Failure of the Display and Control Panel Including Control Unit for Electronically Controlled Air-Conditioning System (BKE): Check Fuse (208/21)

Model Line: **Macan (95B)**

Model Year: **As of 2022**

Fuse box luggage compartment

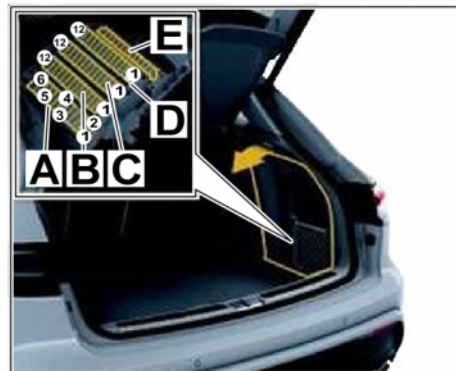
Action required: This may be caused by a defective fuse for the electric air-conditioning system (BKE). An incorrectly installed 10A fuse for the electric air-conditioning system (BKE) was detected during the analysis. In the event of a complaint, check the 10A fuse, which is located in row D, slot no. 8 in the fuse box in the luggage compartment, and replace it with a 15A fuse.

- Work procedure:
- 1 Open the fuse box in the luggage compartment.
 - 2 Replace 10A fuse in row D, slot no. 8 with a 15A fuse.
 - 3 Close fuse box in luggage compartment.
 - 4 Switch on ignition and check whether the fault type has been corrected. If not, continue troubleshooting.
 - 5 Read out the fault memory of the PCM and delete it if necessary.
